**Project: Hurricane Laura Stom Repairs - Rosteet Annex**

**Addendum No. 2**

**Addendum Number 2**  
December 7, 2023

**Calcasieu Parish School Board**  
Rosteet Annex  
Engineer's Project Number: 23023

SHEET ASB1 OF ASB3

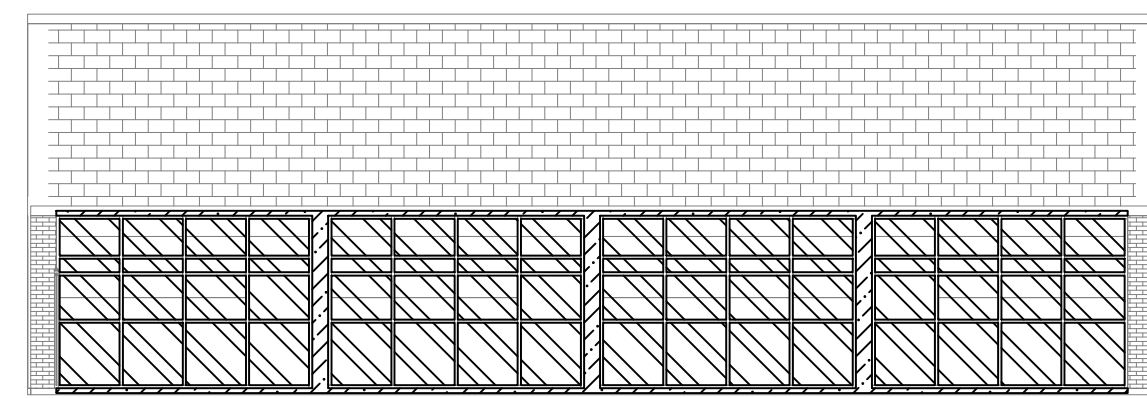
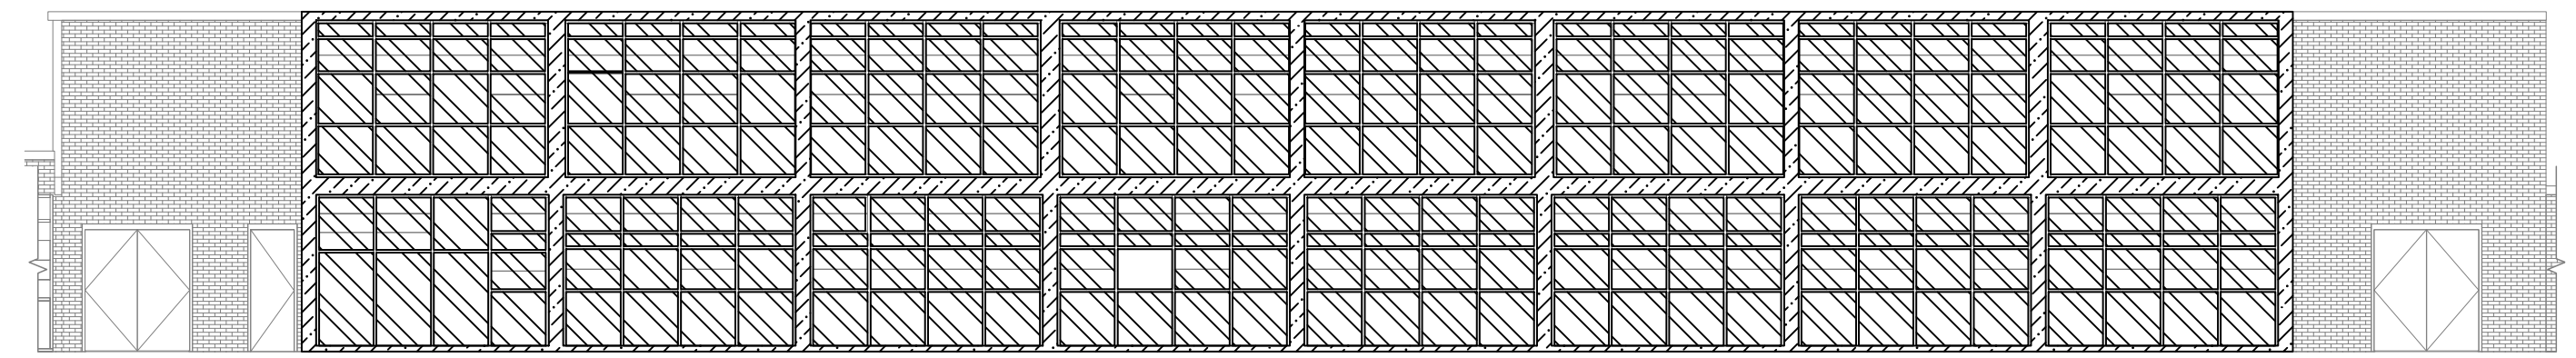
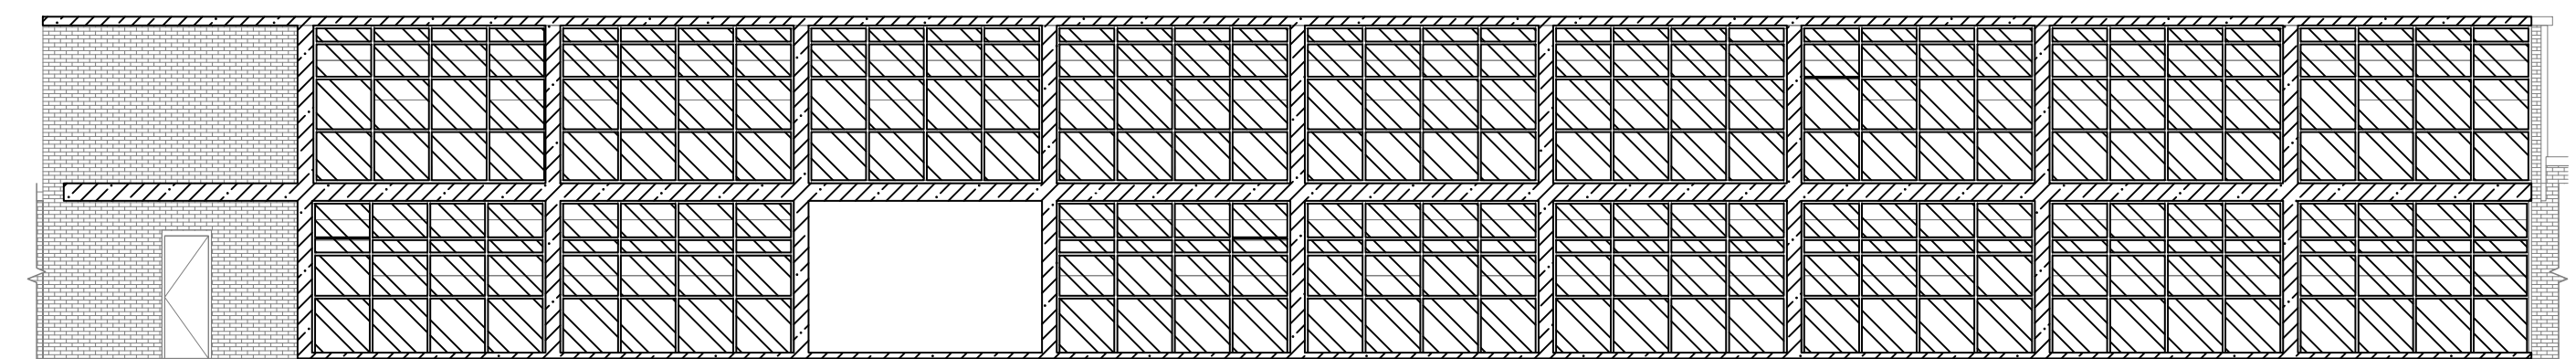
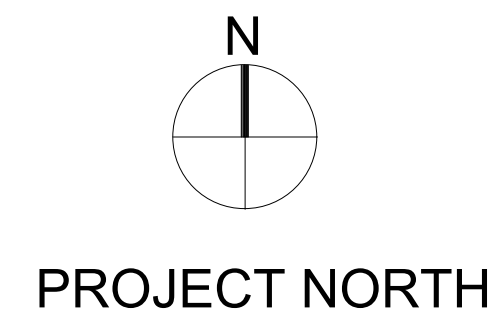
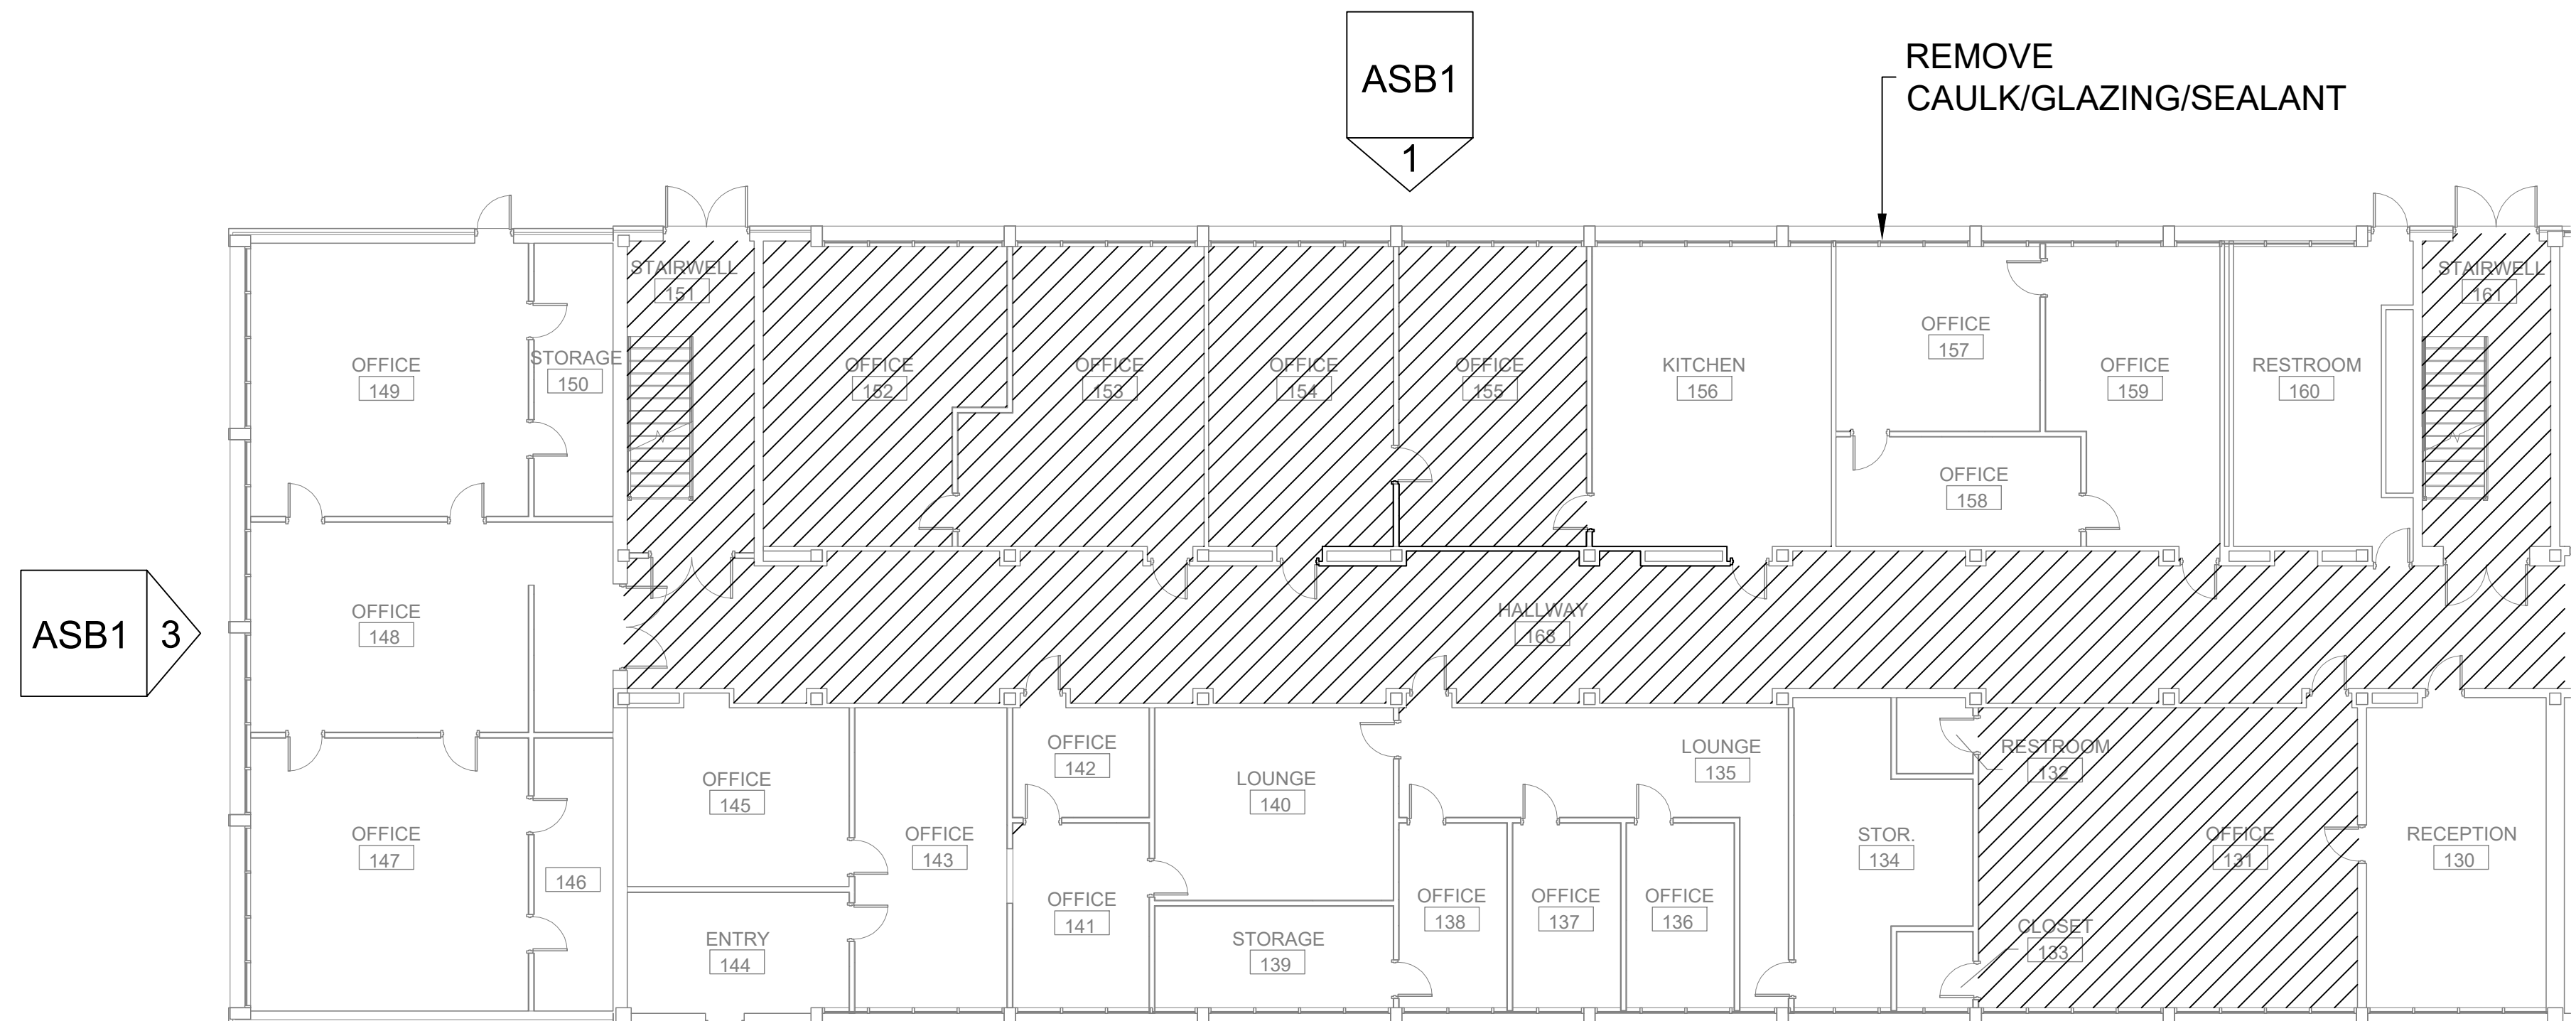
**Item 1** Delete Drawing Sheets ASB1, ASB2 and ASB3 and replace with attached Drawing Sheets ASB1, ASB2, and ASB3 dated 12/7/23.

REMOVE & DISPOSE OF FLOOR  
TILE/MASTIC

REMOVE & DISPOSE OF BROKEN WINDOW  
PANES, CAULK, SEALANT, AND GASKETS.  
COORDINATE WITH GENERAL CONTRACTOR.

REMOVE PLASTER TO SUBSTRATE

REMOVE  
CAULK/GLAZING/SEALANT
